City of Alameda • California

April 27, 2023

Subject: *Major Realignment of Sections of Bay Trail in the City of Alameda*

Figure 8. Trails and Water Crossings Vision Network

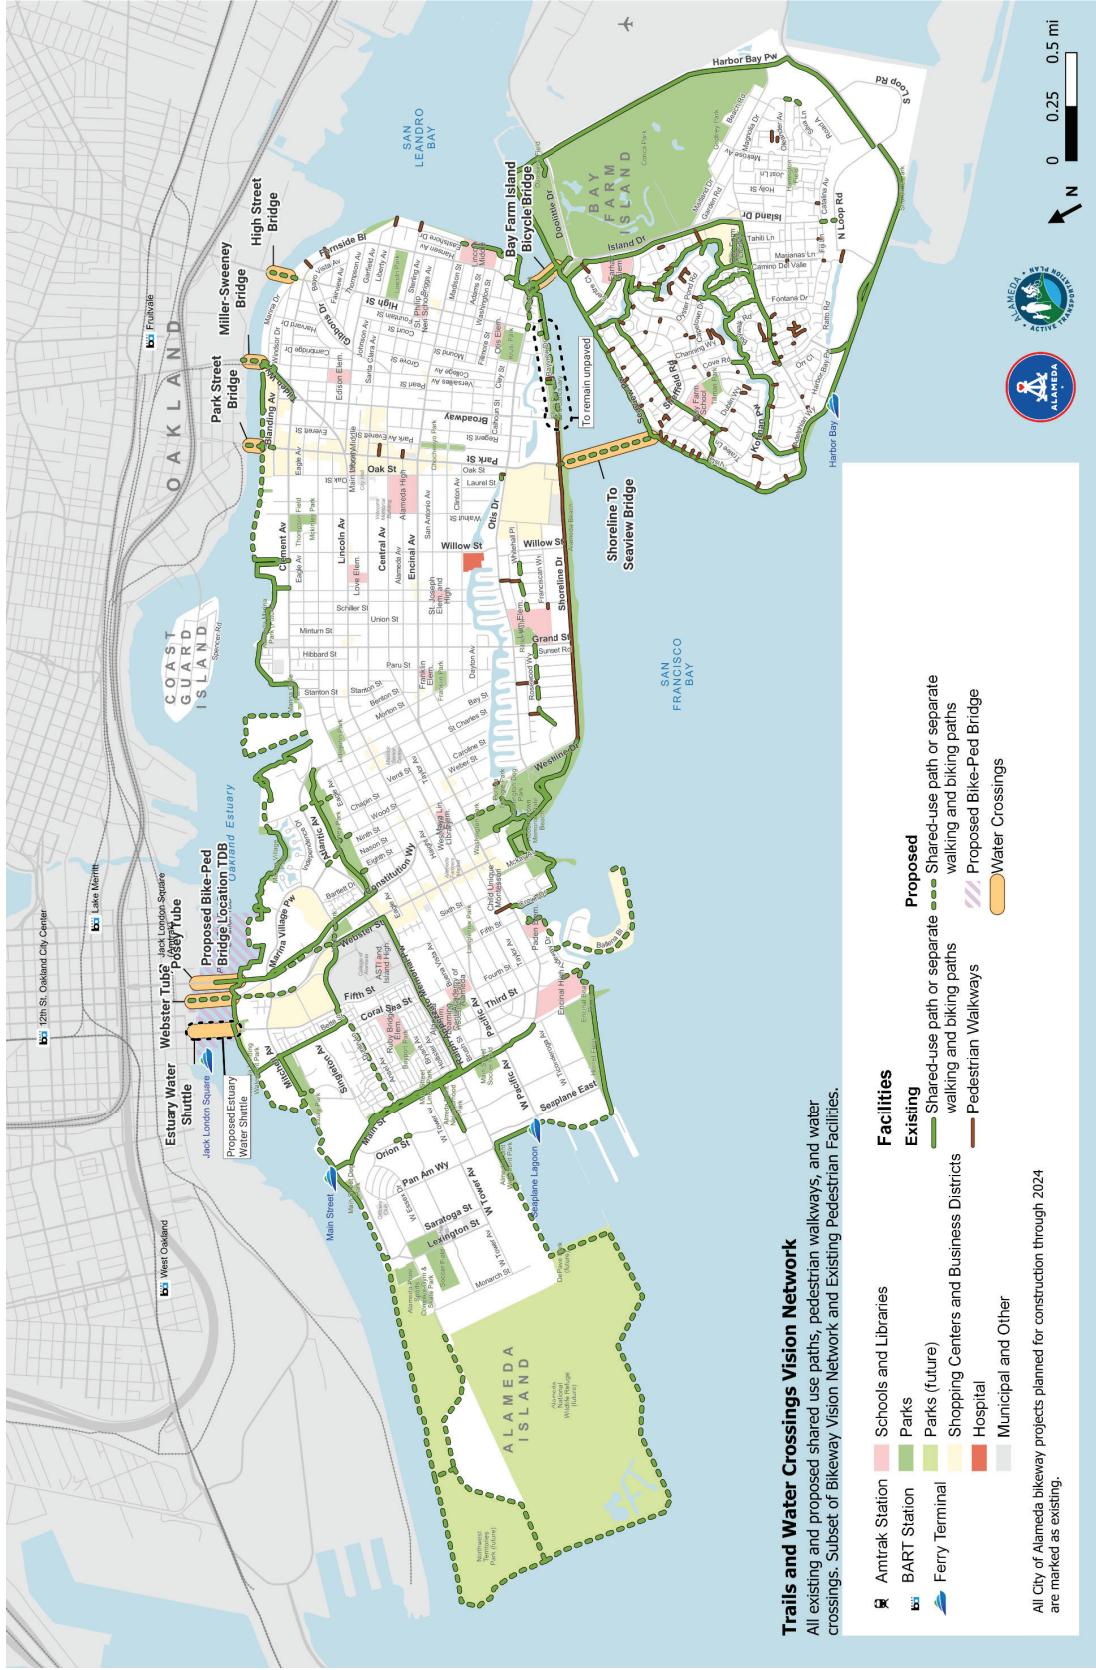
- **ADD** these waterfront alignments along the northern waterfront of Alameda, listed from east to west. The routing is shown in Figure 9 of the ATP, and includes whether the facility is existing or proposed, and on or off street. The facility type can be found in Figure 6 of the ATP.

- Oakland Estuary Waterfront (Miller-Sweeney Bridge to Clement/Stanton)
 - Existing segments:
 - Behind Blanding Shopping Center, along Oakland Estuary
 - Grand Street to Clement/Stanton

- Proposed segments:
 - Tilden Way to Blanding Shopping Center
 - Behind Nob Hill Foods to Grand Street
 - Clement (Stanton St to Entrance Rd) – Existing segment

- Oakland Estuary Waterfront (Clement/Stanton to Shoreline Park Trail near foot of Triumph Dr)
 - Existing segments:
 - Existing Trail along Encinal Basin near Wind River development to Encinal Yacht Club

- Proposed segments:
 - Clement/Stanton to Existing Trail along Encinal Basin near Wind River development
 - Encinal Yacht Club to Shoreline Park Trail near foot of Triumph Dr

- Oakland Estuary Waterfront (Shoreline Park Trail near foot of Triumph Dr to Main Street Ferry Terminal)
 - Existing segments:
 - Shoreline Park Trail near foot of Triumph to Shipways (east side)

- Shipways (west side) to center of Bohol Circle Immigrant Park
 - Proposed segments:
 - Shipways (east to west)
 - Center of Bohol Circle Immigrant Park to Main Street Ferry Terminal

- Park Street Bridge, connecting via Blanding Ave to Oakland Estuary waterfront (Note, however, that the Bridge is owned by Alameda County Public Works Agency.) – Proposed segment

Existing Bay Trail Map for Alameda with Sections to be Removed

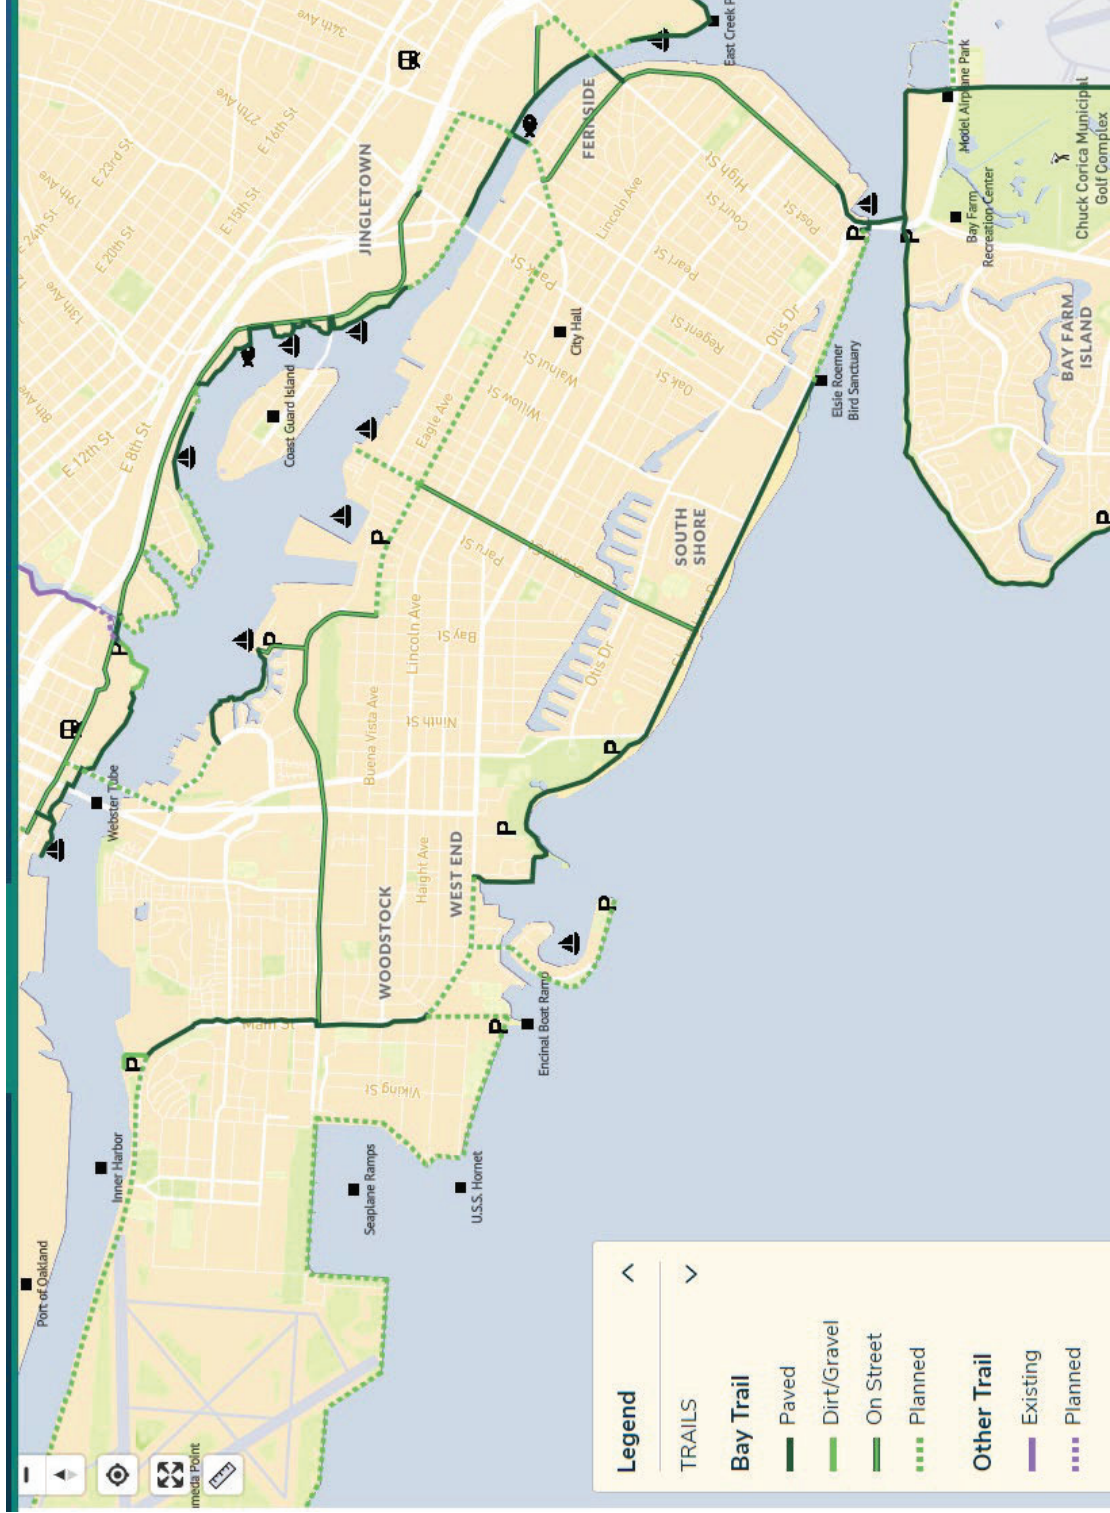
- **REMOVE** the following existing interior alignments from MTC Bay Trail Map:
 - Main St (Main Street Ferry Terminal access road to Pacific Ave)

- Central Ave (Pacific Avenue to Encinal Boat Ramp entrance road)
- Grand St (Shoreline to Oakland Estuary)
- Ralph Appezato Memorial Parkway (Main St to Webster St)

- Atlantic Ave (Webster St to Clement Ave)
- Sherman St (Clement Ave to Buena Vista Ave)
- Buena Vista Ave (Sherman St to Tilden Way)
- Tilden Way (Buena Vista Ave to Fernside/Blanding)

- Triumph Dr (Atlantic Ave to northern end of roadway)
- Shoreline Park Trail (Segment from Oakland Estuary to Marina Village Parkway)
- Marina Village Parkway (Shoreline Park Trail to Posey Tube)
